SYDNEY WESTERN CITY PLANNING PANEL

ADDENDUM REPORT

Panel Reference	PPSSWC-125
DA Number	DA-1059/2020
LGA	Liverpool City Council
Proposed Development	Concept DA for the construction of a cemetery, including mausoleums, crematoria, chapel, hall, gatehouse, administration buildings, café, car park, access roads, landscaping, earthworks and flood management works. Stage 1 seeks consent for the demolition of existing structures, bulk excavation and flood mitigation works for the entire site, including construction of 4 pads, construction of Pad 1 access road, administration buildings, crematoria, waste water treatment and car parking.
Street Address	1290 Greendale Road, Wallacia NSW 2745 (Lot 1 DP 776645)
Applicant/Owner	MKD Architects Pty Ltd/ Soukutsu Pty Ltd
Date of DA Lodgement	15 December 2020
Number of Submissions	56 objections (including 49 individual submissions and 7 proformas)
Recommendation	Deferred commencement approval
Regional Development Criteria (Schedule 6 of the SEPP (Planning Systems) 2021	<p>Clause 2 of Schedule 6 - Development with a Capital Investment Value (CIV) of over \$30 million.</p> <p>The CIV of this application as outlined in a detailed cost report by a r

Figure 1: Extract of Sediment Control and Erosion Control Plan confirming the location of Pad 2.

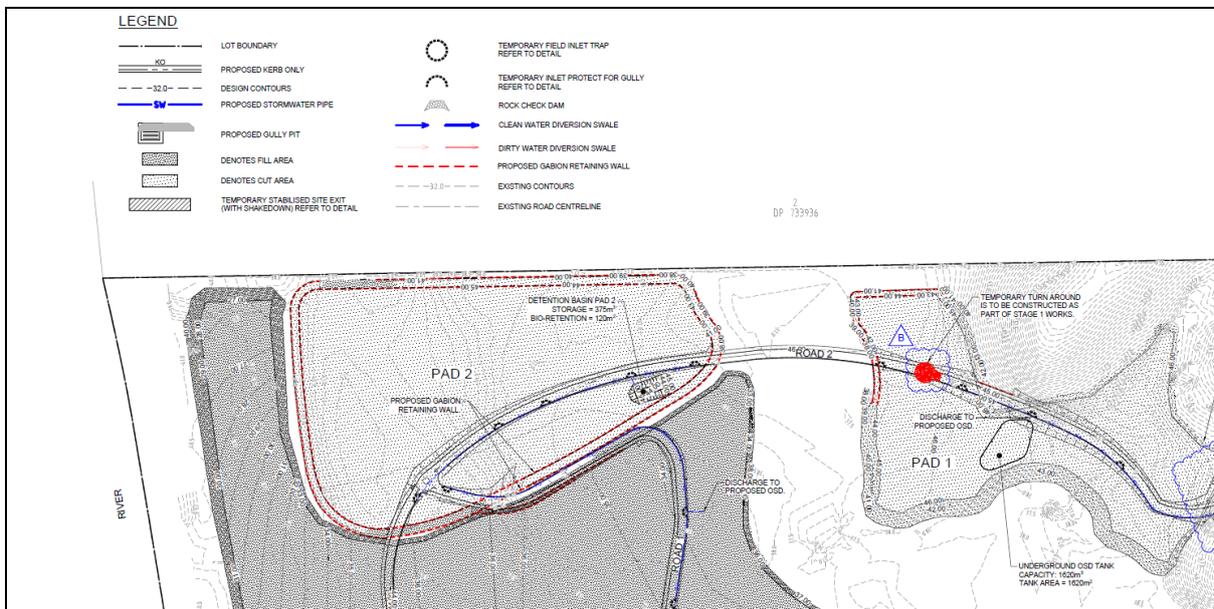
1 c) Jacob Gunther of 1300 Greendale Road referred to the existence of what he described as an alluvial soil profile (not firmer/stiffer residual clays), and proposed side batters of the detention basin and new fill of steeper than 2H:1V which he said would be at risk of severe erosion during a flood event, particularly when factoring seepage which would destabilise the slopes. He reported evidence of land slips on the opposite side of the river. He felt that the geotechnical issues arising from the DA had not properly been considered in the proposal and the study undertaken was based on incorrect information.

Council's response: The submitted bulk earthworks and civil drawings indicate that the area in question is BH4 is near Pad 2 on the north western corner of the site as indicated in **Figures 1 and 2** below.

The submitted Geotechnical report confirmed that no groundwater was found near Pad 2: Only Bore Hole 11 (BH11) on Pad 4 showed any ground water (south east corner of the site).

Furthermore, it is noted that Pad 2 is not part of Stage 1 of the proposed development which is the subject of this application. Council's Land Development Engineer has reviewed the proposal and raised no objection subject to standard conditions requiring sediment and

Figure 3: Extract of Borehole Location Plan confirming the location of BH11.

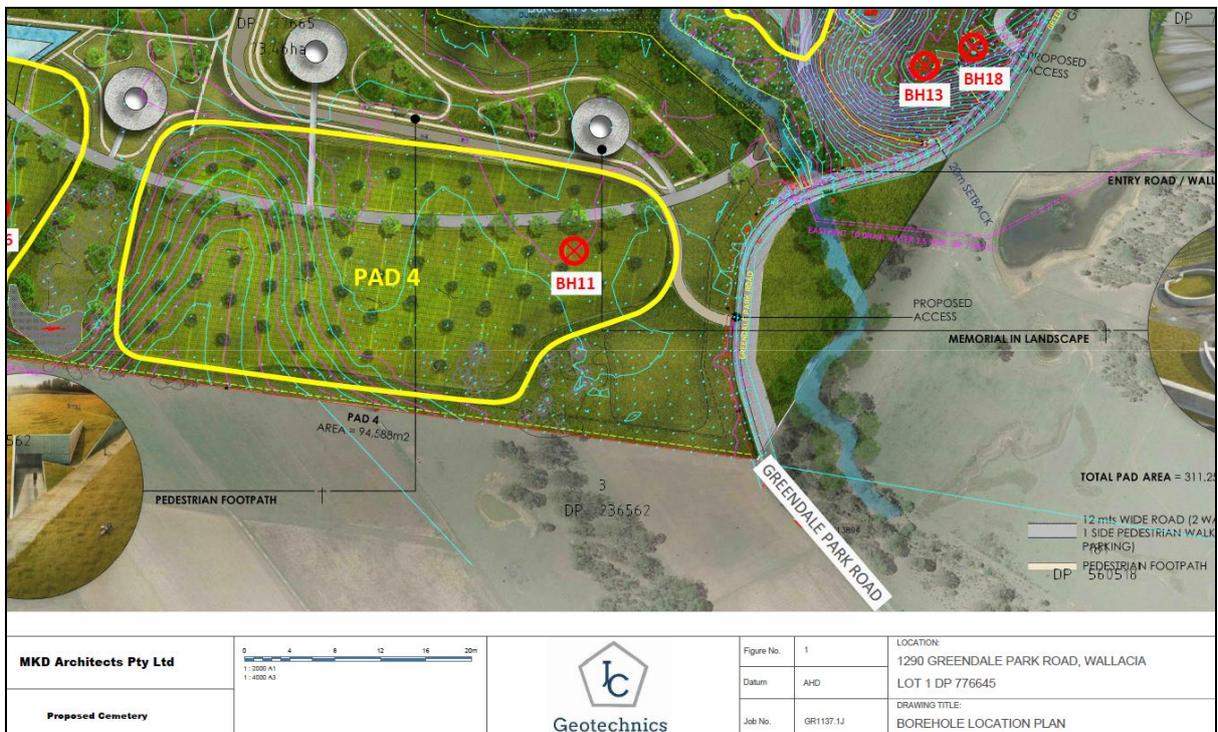
5 According to the geotechnical report, the depth of cut on the site is typically 4 to 6m, but is up to 14m in the north west corner where it would be similar to the water level in the Nepean River. In that context, the Applicant should be asked to confirm if the cut over the site at any location would intercept the groundwater table and, if so, what impact is anticipated on the proposed cut and fill balance to ensure no loss in flood storage.

Furthermore, the supplementary borehole location plan provided in the Geotechnical report prepared by JC Geotechnics Pty Ltd confirms the BH11 is located within the proposed Pad 4 which is located on the south eastern corner of the site (refer to **Figure 3** below).

It is noted that Pad 4 requires filling up to 6m above the existing levels with no excavation within this portion of the site.

The applicant has satisfactorily confirmed that there is no likely interception of ground water by the cut proposed for the site and as such this issue is considered to be resolved.

Figure 4: Vegetation Mapping of the Cumberland Plain (source: NSW NPWS 2002).

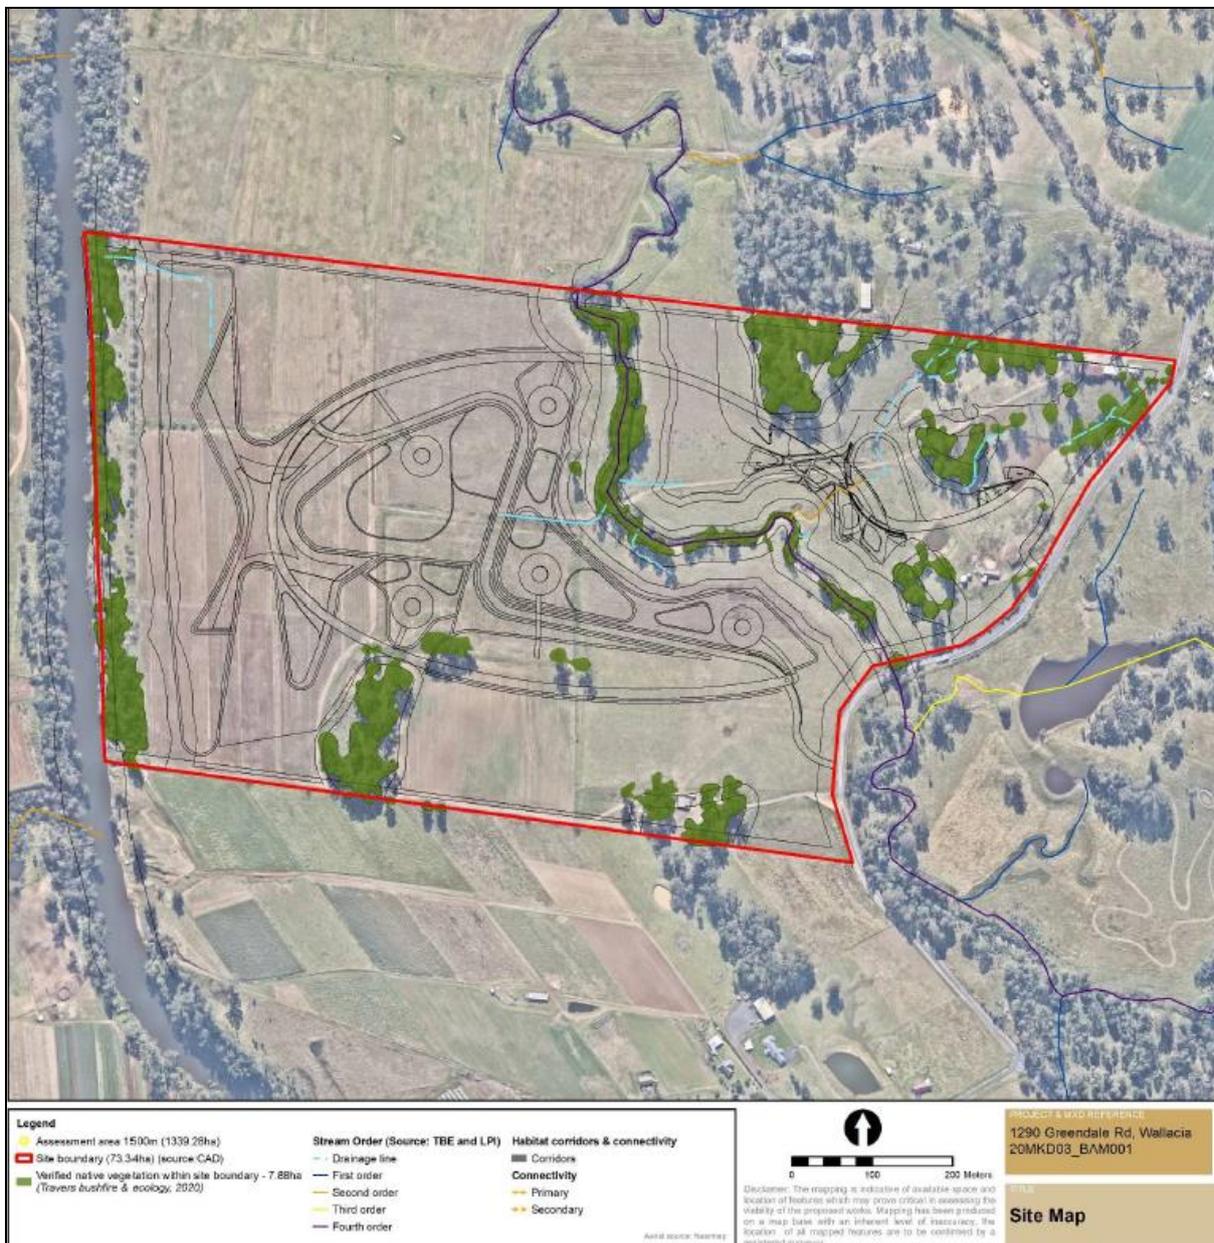
2. *Is there any reason why the proposed development is not restricted to the relatively high ground at the site, as opposed to encroaching to the Nepean River? Is it because of the assessed scale of demand for the facilities? A comment was made on site by Council's Planner, Kevin Kim, that there were ecological constraints to development on some of the higher ground?*

Council's response: The submitted Biodiversity Assessment Report (BAR) with the application confirms that a large portion of the high ground (north eastern part of the site) contains existing native vegetation as illustrated in **Figure 4** below.

The proposed development incorporates a vegetation management plan that maximises the retention of existing native vegetation with an overall increase in 9.96ha of vegetation to compensate the loss of native vegetation. This is achieved by keeping the high ground part of the site unchanged with existing native vegetation. Therefore the development has been designed to provide structures that are scattered across the site that are identified as being appropriate in regard to other environmental constraints.
